San Francisquito Creek Flood Protection, Ecosystem Restoration, and Recreation Project Upstream of Highway 101

Final Environmental Impact Report – September 2019 Volume 2: Appendices

Appendix A

Figure 1
Access Ramp 1

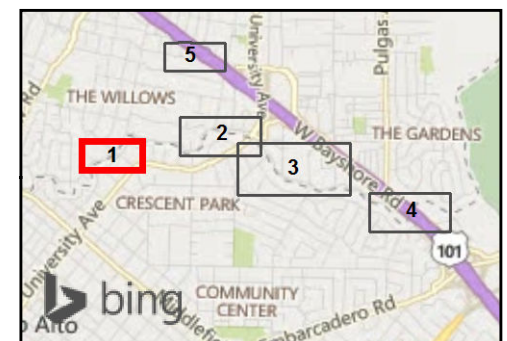
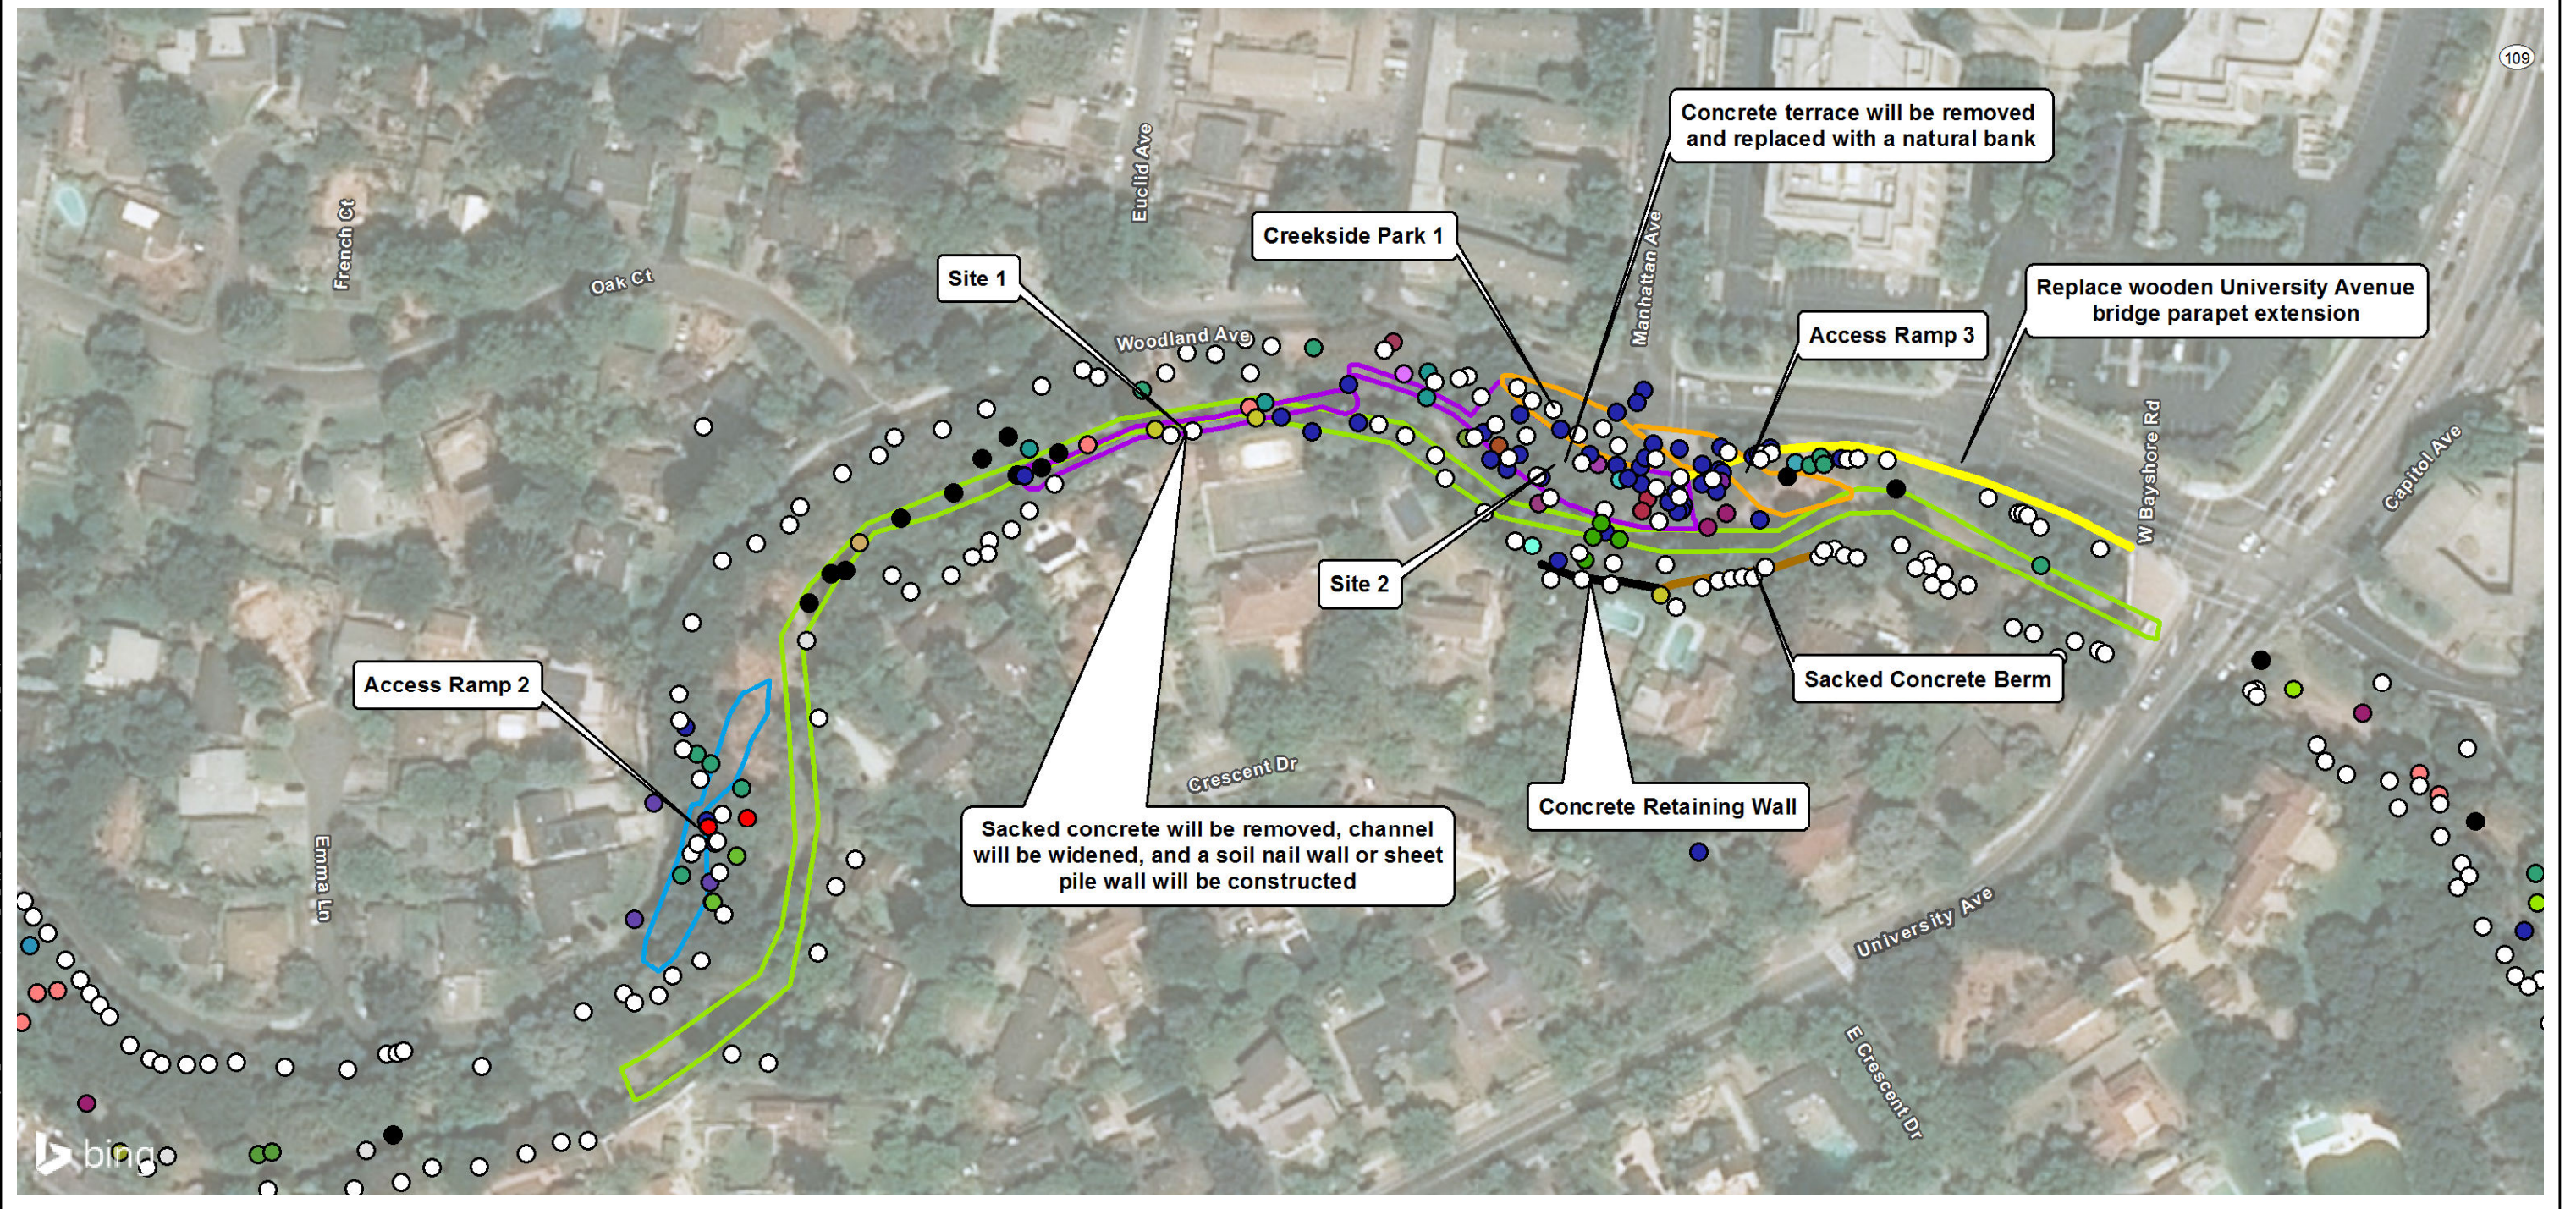
A2	23	City of East Palo Alto	3.3-78 – 3.3-82; Table 3.3.7, and Figures 1 to 3 in Appendix B	The comment requests information regarding impacts to trees and compensation for impacts to trees. The comment also requests that an arborist be involved as part of the design team, that tree protection plans be submitted prior to project approval, questions whether the Project Arborist is a third-party contractor, and notes that permits are required for heritage tree removal requests.	The SFCJPA has developed the preliminary design for the proposed project to avoid and minimize environmental impacts, including impacts to trees. Additional information regarding trees that may be removed during construction has been added to the Final EIR in Table 3.3-7, pages 3.3-78 to 3.3-82, and Figures 1 to 3 in Appendix B, showing potential tree removal locations. Tree pruning may occur throughout the project area; however there are no specific maps depicting specifically where this pruning would occur as the level of design to identify exactly where pruning may occur is not yet available. Under Impact BIO-5, <i>Result in disturbance or loss of locally protected trees</i> , MM-BIO-12 discusses compensation for tree removal. Compensation as part of MM-BIO-12 would only apply for trees removed as part of the project and would not include compensation for construction impacts adjacent trees as requested in the comment.

A3	11	California Department of Fish and Wildlife	3.3-78 – 3.3-82; Table 3.3.7, and Figures 1 to 3 in Appendix B	The comment states that the number of trees to be impacted by the proposed project needs to be more clearly described, as well as whether these trees are in the riparian corridor or in upland locations. In addition, it states that the EIR should include more defined mitigation measures to compensate for impacts to both riparian and upland vegetation.	Additional information regarding trees that may be removed during construction has been added to Table 3.3-7, pages 3.3-78 to 3.3-82, and Figures 1 to 3 in Appendix B of the Final EIR. In addition, Impact BIO-2's discussion of potential impacts to riparian habitat and riparian restoration has been updated to better describe and quantify impacts to sensitive natural communities and land cover types. MM-BIO-8 includes measures to restore riparian habitat. The discussion of tree impacts in Impact BIO-5 has also been updated to provide more information on tree species, diameter at breast height, and location (pages

I11	1	Dorian West	3.3-78 – 3.3-82; Table 3.3.7, and Figures 1 to 3 in Appendix B	The comment requests that a specific plan for individual tree removal be included, in order to properly assess how impacts to trees would be minimized.	Additional information regarding trees that may be removed during construction has been added to the Final EIR in Table 3.3-7, pages 3.3-78 to 3.3-82, and Figures 1 to 3 in Appendix B, showing potential tree removal locations. Table 3.3-7 shows the trees that are expected to be removed at each site. As discussed in the Draft EIR, implementation of MM-BIO-12 and MM-BIO-13 would reduce project-related impacts on protected trees to a less-than-significant level. MM-BIO-13 includes preparation of a tree protection plan by a licensed arborist, among other measures.
I11	2	Dorian West	2-7 – 2-10	The comment states that Pope-Chaucer Bridge should allow a pedestrian and bike activity as the primary form of traffic.	Sidewalks and bike lanes will be included in the design of the bridge. The SFCJPA has concluded that it is not feasible to remove vehicular traffic from the bridge. As described in Chapter 2, <i>Program Description</i> , of the Draft EIR, an alternative was considered that would include removal of the Pope-Chaucer Bridge. That alternative, Alternative 11, Remove the Pope-Chaucer Bridge and Increase Capacity Downstream, was not carried forward for

I42	3	Jeff Prudhomme	3.3-78 – 3.3-82; Table 3.3.7, and Figures 1 to 3	The comment states that the trees proposed to be removed along the creek bank should be mapped so that nearby residents can easily identify them and provide input.	Additional information regarding trees that may be removed during construction has been added to the Final EIR in Table 3.3-7, pages 3.3-78 to 3.3-82, and Figures 1 to 3 in Appendix B, showing potential tree removal locations.

Letter	Comment #	Commenter	Final EIR Page #	Summary of Comment	Response to Comment
					that may be removed during construction has been added to the Final EIR in Table 3.3-7 and Figures 1 to 3 in Appendix B, showing potential tree removal locations.
A2	12	City of East Palo Alto	2-31; 3.13-8	The commenter reiterates some of the information provided on page 2-31 of the Draft EIR, regarding traffic management, and notes that a complete traffic control plan will be required for review/approval by the City of East Palo Alto prior to project construction.	As discussed on page 3.13-8 of the EIR, implementation of MM-TT-2 would require preparation of a site-specific traffic control plan. As stated in the text of MM-TT-2, the plan will be subject to review and approval by the City of East Palo Alto. MM-TT-2 also provides a list of the general requirements for what the plan should contain.
A2	13	City of East Palo Alto	2-34; Figure 2-3 / 2-19; Figure 2-4 / 2-20	The commenter notes that the project could include construction of two small Creekside parks in the City of East Palo Alto, and that the design of the parks should be coordinated with the City's Public Works Department.	As discussed in Chapter 2, <i>Program Description</i> , of the EIR, both the Channel Widening and Floodwalls Alternatives could include construction of Creekside parks, page 2-34. As noted by the commenter, the locations of the potential parks is shown in Figures 2-3 and 2-4 of the EIR. Design, operation, and maintenance of these parks would be coordinated with the City of East Palo Alto.

Figure 2
Site 1 and 2 Construction Elements

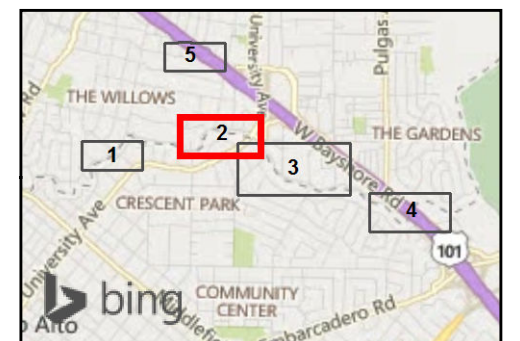
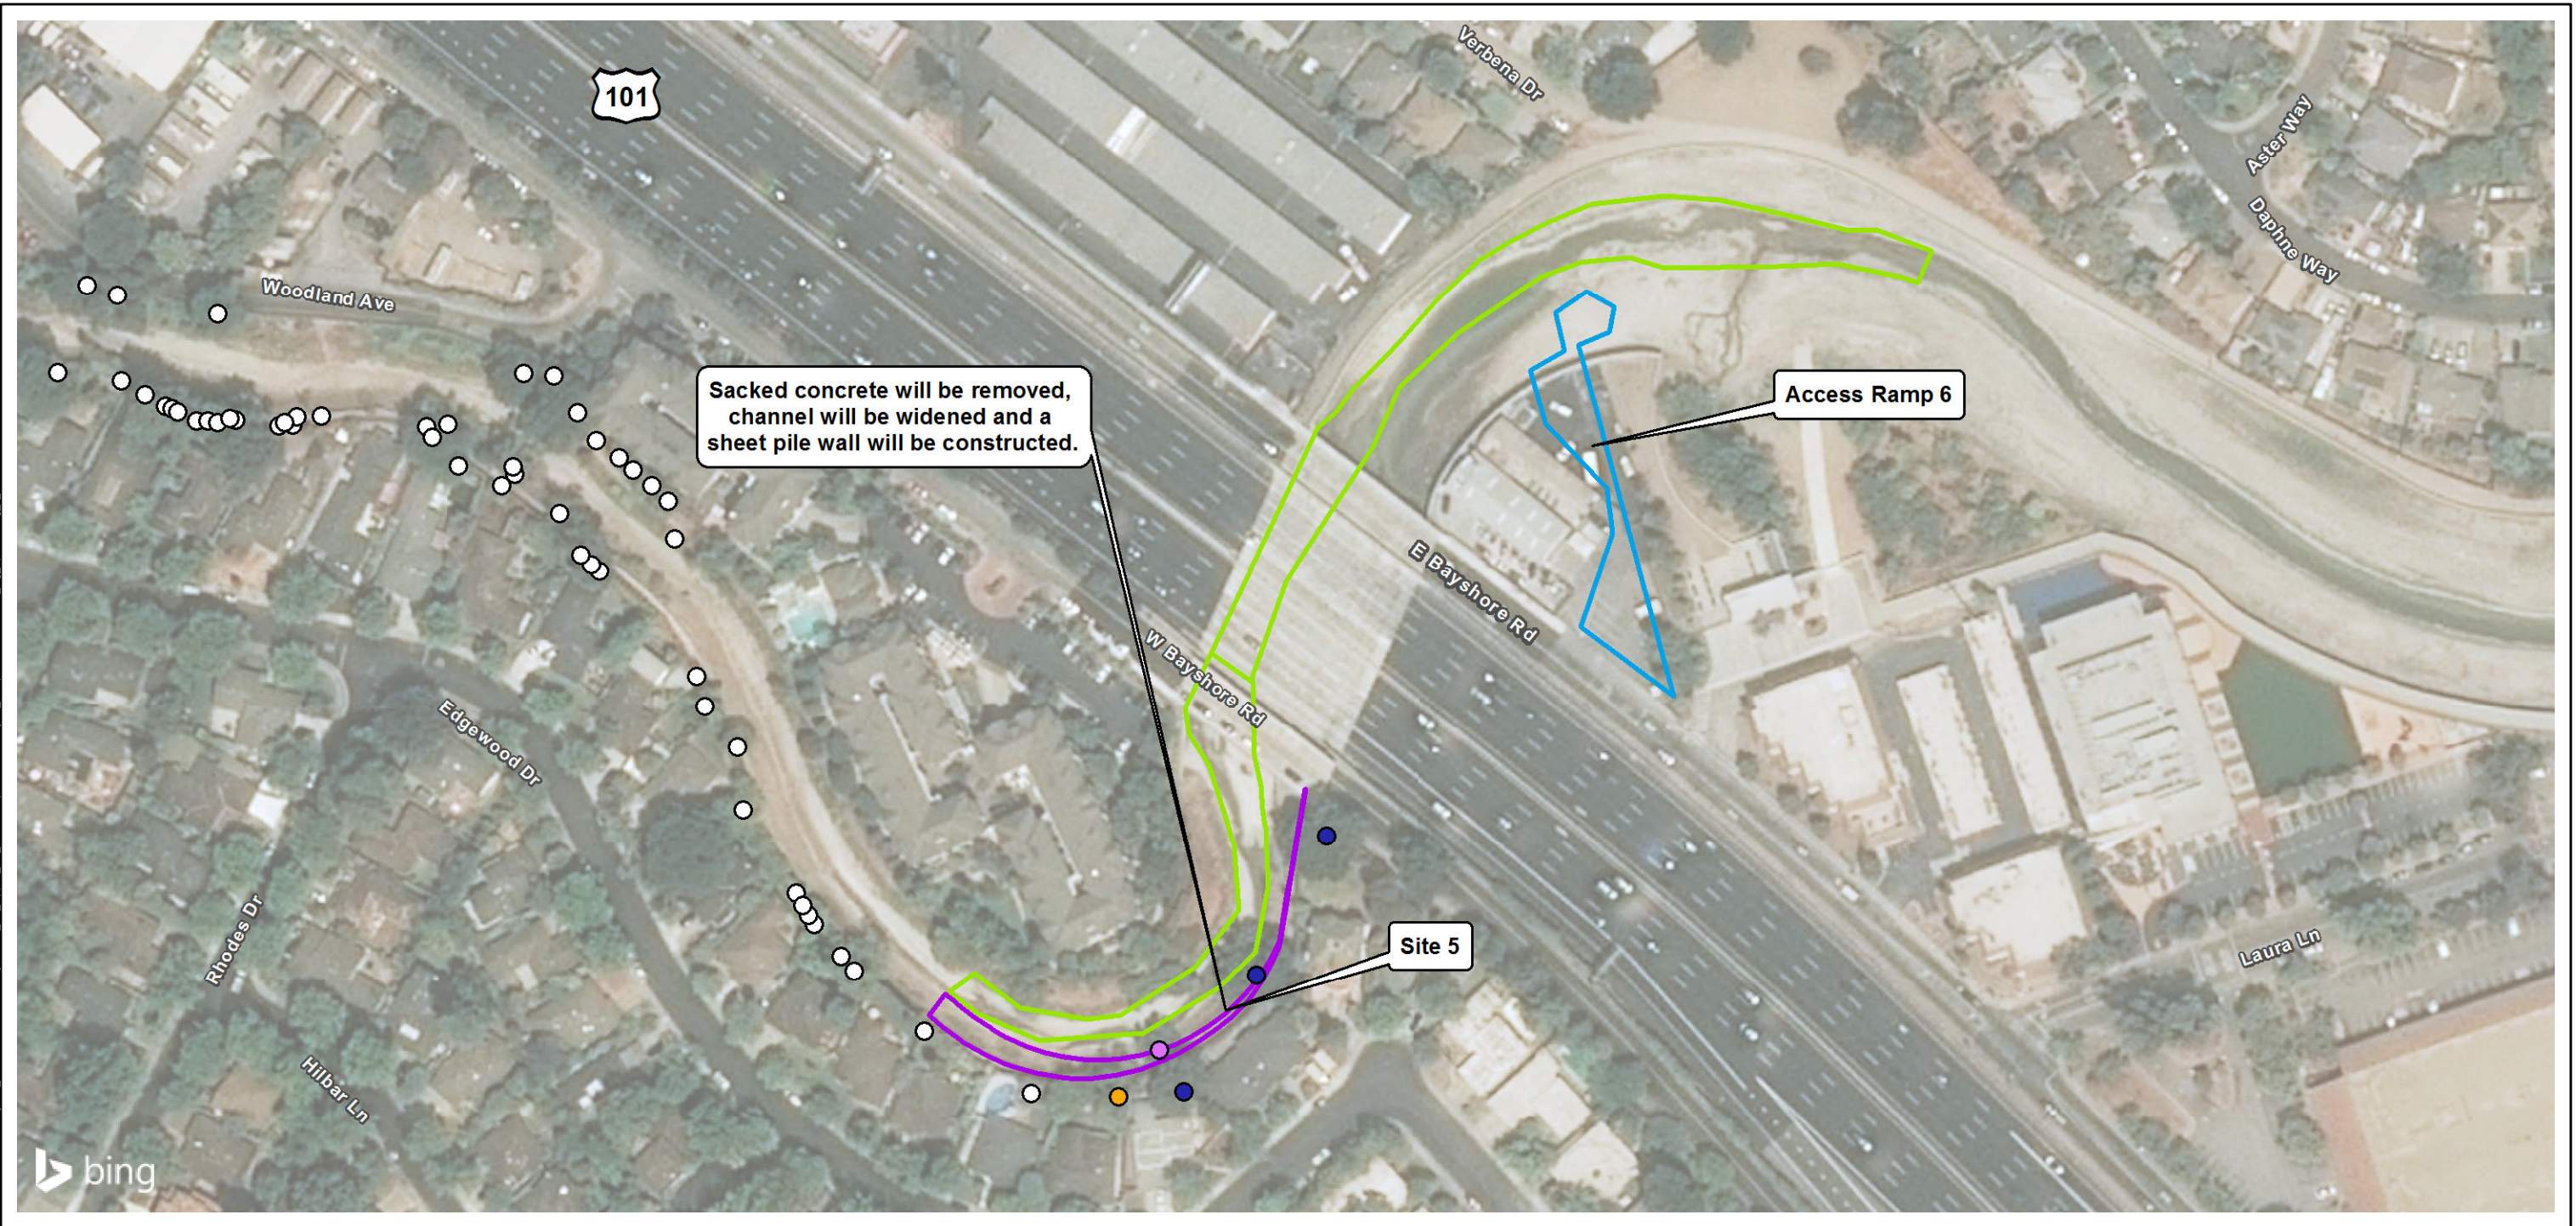
I21	2	Naomi Goodman	3.3-78 – 3.3-82; Table 3.3.7, and Figures 1 to 3 in Appendix B	The comment states that the removal of vegetation 250 feet upstream and downstream of the Pope-Chaucer Bridge would have a significant impact as there are at least 12 mature oak trees and one laurel tree along this stretch of the creek.	Additional information regarding trees that may be removed during construction has been added to the Final EIR in Table 3.3-7, pages 3.3-78 to 3.3-82, and Figures 1 to 3 in Appendix B, showing potential tree removal locations. The SFCJPA will preserve as many existing trees as possible, and tree removal and subsequent replanting of trees will be discussed with each city according to its ordinances.

PH1	4	Public Hearing 1	3.3-78 – 3.3-82; Table 3.3.7, and Figures 1 to 3 in Appendix B	The comment requests detail about proposed tree removal upstream and downstream of the Pope-Chaucer Bridge.	Additional information regarding trees that may be removed during construction has been added to the Final EIR in Table 3.3-7, pages 3.3-78 to 3.3-82, and Figures 1 to 3 in Appendix B, showing potential tree removal locations. As noted on page 3.3-81, implementation of MM-BIO-12 and MM BIO-13 would reduce impacts on protected trees to a less-than-significant level.
PH1	5	Public Hearing 1	N/A	The commenter asks to see a rendering of the Pope-Chaucer Bridge but does not include a clear comment or question.	This comment does not raise a specific issue on the substance of the Draft EIR. The public meeting presentation included aerial renderings of new bridge next to images of the current bridge.
PH1	6	Public Hearing 1	N/A	The comment asks if an aerial rendering of the proposed bridge next to the existing Pope-Chaucer Bridge could be made available. Additionally, the comment asks several questions about the proposed bridge and roadway designs.	The public meeting presentation included aerial renderings of new bridge next to images of the current bridge. An updated figure has been included on page 3.1-9 in the Final EIR with the caption "Pope-Chaucer Bridge looking downstream" that provides a better perspective of the bridge for comparative purposes. This comment does not raise a specific issue on the substance of the Draft EIR.

Figure 3
Site 5 Construction Elements

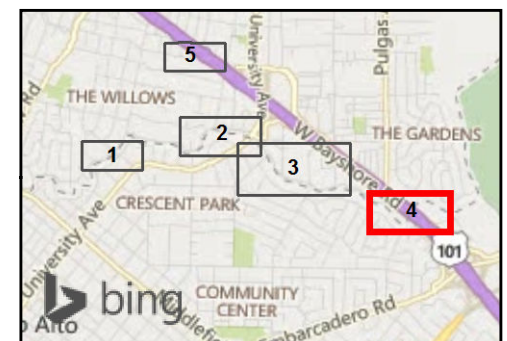
I34	3	Jeffrey Shore	N/A	The comment states that more information on the existing conditions immediately upstream of West Bayshore Road at Site 5 is needed to adequately describe current conditions at Site 5.	Detailed information about hydraulic conditions can be obtained by contacting SFCJPA staff. This level of detail is not required under CEQA.
I34	4	Jeffrey Shore	3.1-10; 3.3-78 – 3.3-82; Table 3.3.7, and Figures 1 to 3 in Appendix B	The comment states that more information on the existing trees at Site 5 needs to be included, specifically, where the trees are located and which provide natural screening.	As described on page 3.1-10 of the Draft EIR, vegetation along this portion of the creek is not very dense, and views of Site 5 are available from the building on West Bayshore Road and between gaps in the sound walls along U.S. 101. However, fencing and landscaping block views from the residences. There are no scenic views associated with this site, and the project would not cause substantial degradation of the visual character or quality of the project site or its surroundings. Section 3.3, <i>Biological Resources</i> , also describes existing vegetation within the project footprint and analyzes impacts to trees throughout the project area resulting from the project. As required by MM-BIO-13, <i>Protect trees from construction impacts</i> , a number of steps would be taken at Sites 1, 3, 4, and 5 to reduce impacts on trees and maintain their health and vitality. This mitigation measure includes preparation of a detailed arborist report, including an inventory of existing trees and a plan for protecting trees that could

Letter	Comment #	Commenter	Final EIR Page #	Summary of Comment	Response to Comment
					be affected by project construction. See also response to comment A2-16, regarding visual impacts at Site 5. Additional information regarding trees that may be removed during construction has been added to the Final EIR in Table 3.3-7, pages 3.3-78 to 3.3-82, and Figures 1 to 3 in Appendix B, showing potential tree removal locations. Top of bank trees not located within of the top of bank widening footprint from West Bayshore Road to approximately 80 feet upstream of West Bayshore Road will be protected in place whenever possible.
I34	5	Jeffrey Shore	N/A	The comment notes that it is confusing whether the proposed retaining wall (soil-nail wall or sheet-pile wall), would replace the existing cinderblock floodwall at Site 5 entirely, or if it would just supplement the existing wall. Additionally, the comment states that more details on the proposed excavation activities and construction setbacks at Site 5 should be provided in the document.	At the location of greatest widening, adjacent to the West Bayshore Bridge, Site 5 top of bank will be widened from approximately 90 feet (existing width) to approximately 120 feet. Top of bank widening tapers back to conform with existing top of bank approximately 80 feet upstream of West Bayshore Road. The existing top of bank floodwall will be replaced by sheet pile wall from West Bayshore Road to approximately 400 feet upstream of West Bayshore Road. The new sheet pile will be located consistent with the new top of bank in the widened area from West Bayshore Road to approximately 80 feet upstream. The new sheet pile wall from 80 feet to approximately 400 feet upstream of West Bayshore Road will be installed along the alignment of the existing floodwall. The SFCJPA will review design plans and discuss any concerns with adjacent homeowners prior to construction.
